OICA/CLEPA Input

Special interest group on UN-R 157

Explanation of proposed Lane Change parameters

5.2.6.9.1.

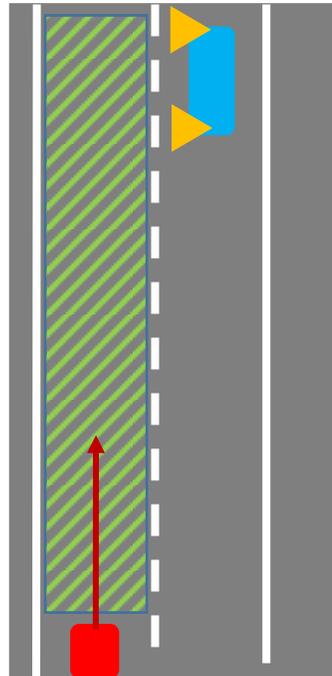
An approaching vehicle in the target lane should not have to decelerate at a higher level than **A** m/s², **B** seconds after the ALKS vehicle starts crossing a lane marking, to ensure the distance between the two vehicles is never less than that which the lane change vehicle travels in **C** seconds.

... 3,7m/s ² | Deceleration of the vehicle approaching from the rear. For MRM maneuvers, we should not leave an additional comfort margin and use the available 3,7m/s ² . |

... 0,4s
... 1,4s | Assumption on reaction time of the vehicle approaching from the rear. If the driver had already been warned by activated Hazard warning lights, the reaction can be assumed to be faster. Note: This is starting at the lane marking, so there was reaction time when the ALKS vehicle moves inside the lane already. |

... 1s | This describes the remaining safety distance at the end of the braking maneuver of the approaching vehicle. For MRM maneuvers, a smaller value should be acceptable, to make these LC possible. |

5.2.6.9.3.

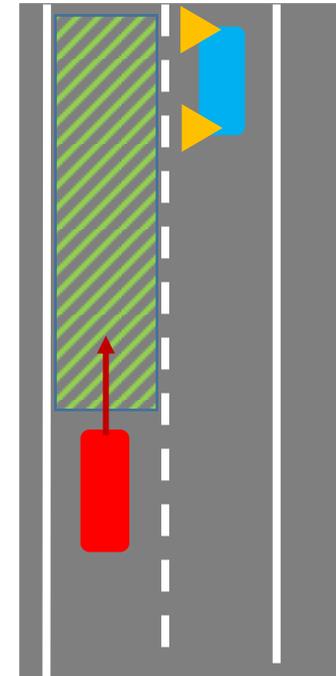
Explanation: The required detection distance to the rear is derived from the estimation at which distance another vehicle would need to be detected in order to not be forced to unreasonably decelerate

Explanation: In order to achieve a reasonable distance (if using any speed then the distance becomes infinitely high) reasonable assumptions about the speed of another vehicle need to be made -> therefore “whichever is higher” does not work, as this would require to use 400km/h on German motorways.

Explanation: Hard shoulders are commonly used when e.g. there is slow moving traffic before a highway exit. Then the speed of a vehicle on the hard shoulder is not tremendously faster than that of the vehicles in the adjacent lane, as hard shoulders are usually very narrow.

5.2.6.9.4. When there is an equally fast or slower moving vehicle

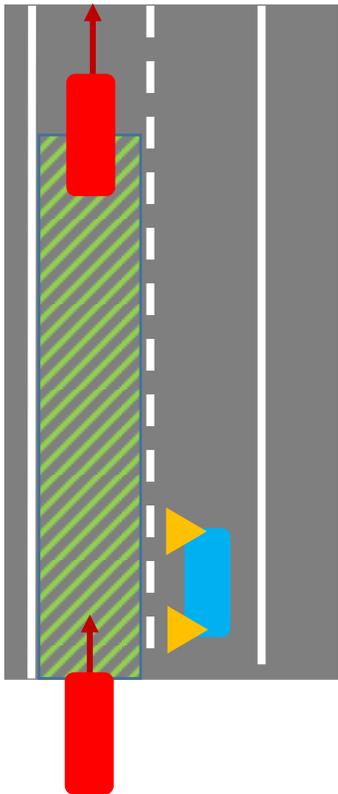
At the beginning of the LCM, the distance between the rear of the ALKS vehicle and the front of a vehicle following behind in the target lane at equal or lower longitudinal speed shall never be less than the speed which the following vehicle in target lane travels in:

- (a) 0.7s for a lane change during a minimal risk manoeuvre**
- (b) 1.0s for a regular lane change.**

Explanation: This describes the permitted minimum distances between these two vehicles at the beginning of the LCM, when there was never a risk of collision (as the following vehicle travels equally fast or slower). For MRM LC this value should be decreased compared to a comfort LC, as we aim to make these lane changes possible, even in dense traffic and there is no direct risk related to this lower value.
